# 1989 - 1991 Corvette: Service Bulletin: No/Delayed Reverse When Cold

**Subject:** NO/DELAYED REVERSE WHEN COLD INSTALL REV.  
INPUT CLUTCH SEAL

**Bulletin Number:** 91-493-7A - (03/11/1992)

1989-91 HYDRA-MATIC 4L60 (MD8)

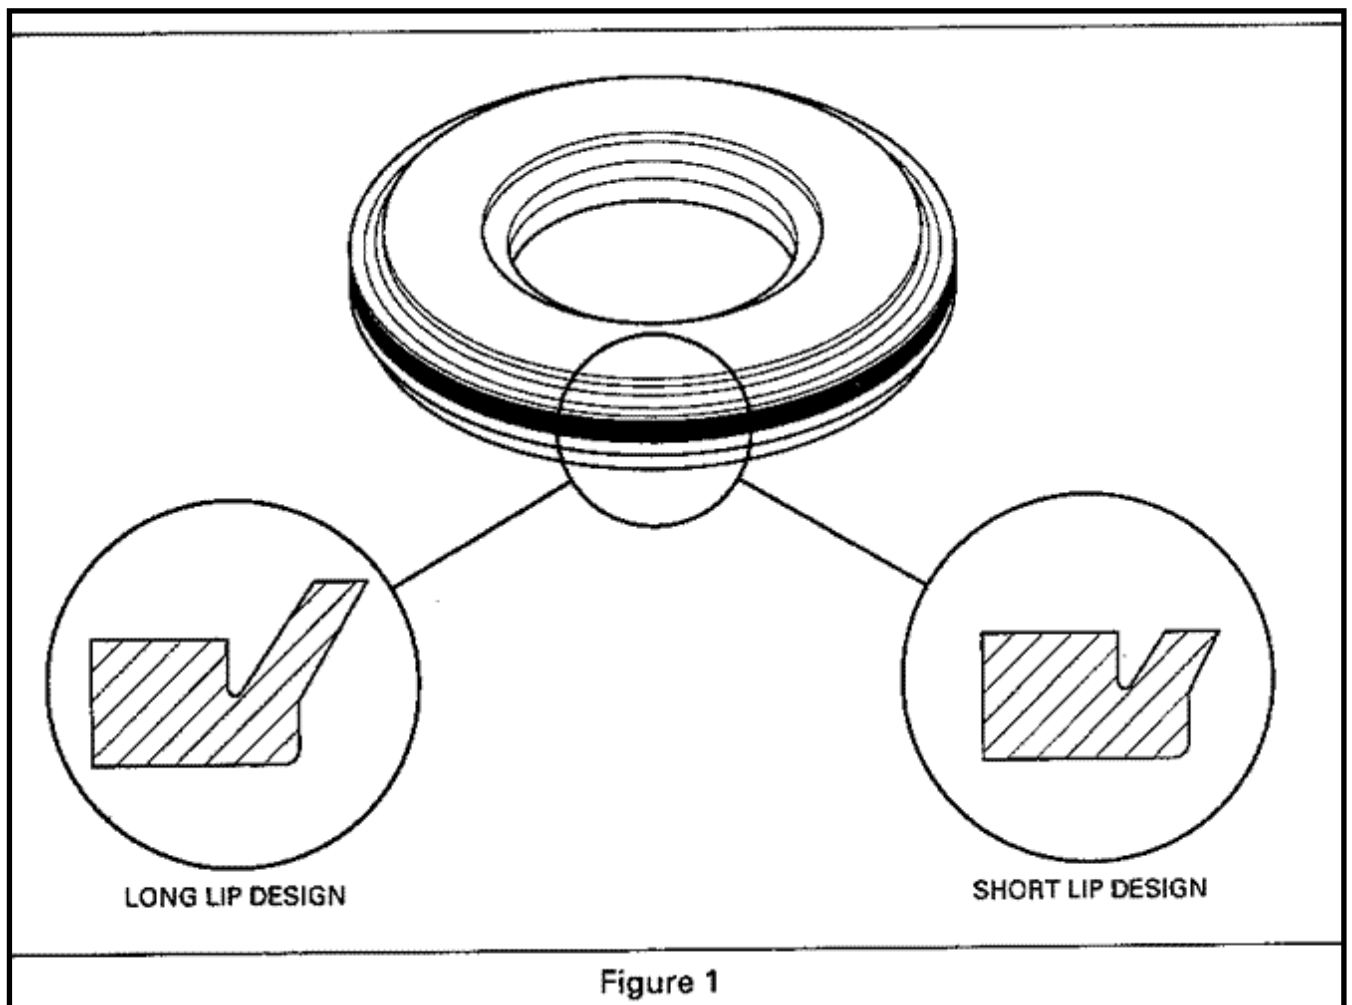
If a transmission has a 'no reverse' or 'delayed reverse' condition, inspect the reverse input clutch piston outer seal. Determine if the seal is a 'short lip' or 'long lip' design by comparing it to Figure 1. If it is a short lip design, replace it with a long lip seal contained in the service packages listed under Service Parts Information.

If the reverse input clutch piston outer seal is a long lip design, or the newly installed long lip seal doesn't alleviate the delayed reverse condition, the reverse input clutch housing may be out of round. Inspect the housing and replace if necessary.
